REZONING SNAPSHOT: Z2025-23

Rezoning Request: R-20 in Cobb County to PRD-SF in City of Marietta

REZONING APPLICATION ANALYSIS

ZONING CASE #: Z2025-23

Powder Springs Road Residences

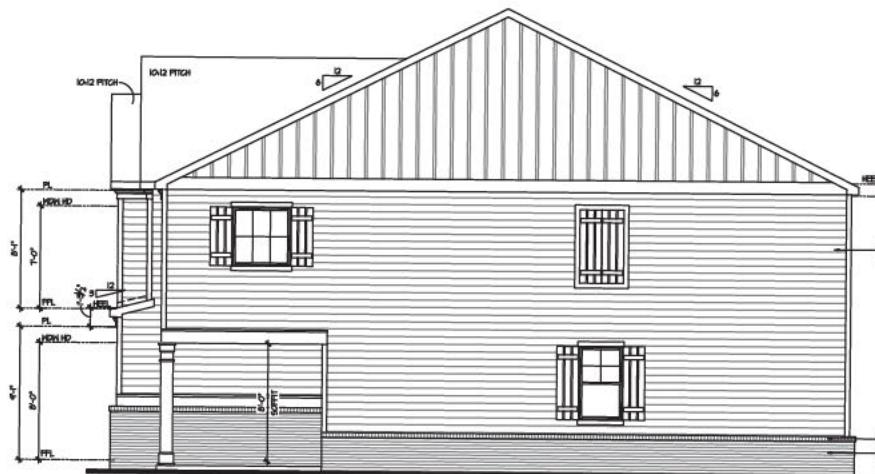
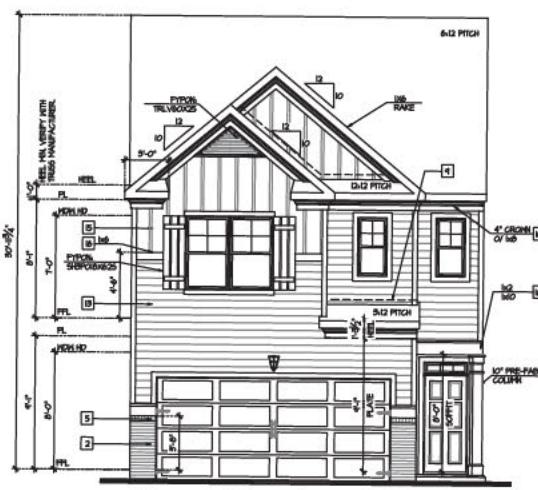
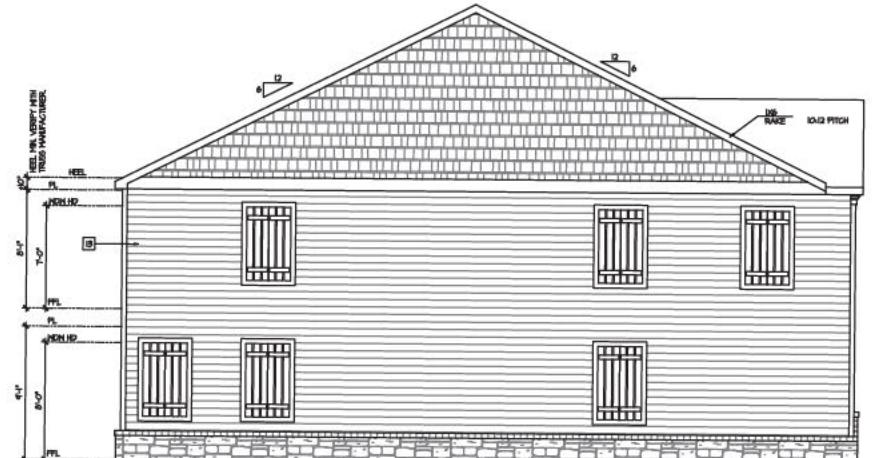
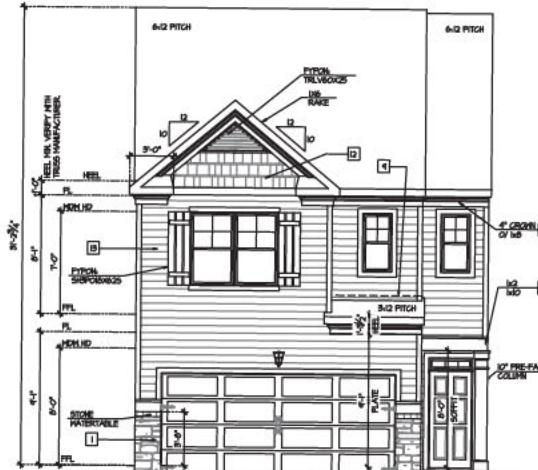
A development of no more than 60 detached, single-family homes is proposed to be built using a single access point from Powder Springs Road. Other features include:

- Minimum lot size of 3,000 square feet with lots measuring 35 feet wide. Small lot sizes are being suggested to make efficient use of the land and offer the consumer a more affordable product. The proposal will require a variance as regulations require lots to be a minimum of 4,000 square feet.

- Areas are earmarked for passive and active recreation. Although not illustrated or described in detail, it appears around 54,000 square feet, or 1.2 acres, is proposed in three (3) different places on the outer edges of the development. One area is noted as a proposed playground, which would satisfy the active recreation requirement. However, it appears the facility would be out of the 300-foot range of about half of the residences, whereas code states that 75% of homes must be within 300 feet of the active recreation component. A variance would therefore be needed if the plan proceeds as presented. Regardless, all areas would have to have ADA compliant accessibility per code.

Only one entrance is provided to the development. Per code, two (2) access points to arterial or collector streets. are required for single-family developments containing more than 51 dwelling units. The following variance would therefore be required:

Entrance onto the site is currently shown to be a 30-foot radius, 35-foot radius is required. Roads within the development will require a minimum radius of 28-feet, and 26-foot face of curb to face of curb bump outs at the locations of fire hydrants for 40 linear feet centered on the hydrant to comply with state fire code for access roads (IFC D103.1). Fire sprinklers will likely be required, depending on the configuration of the building on the lot. A consultation with a fire protection engineer or fire sprinkler contractor is strongly encouraged before specifying water meter size, and
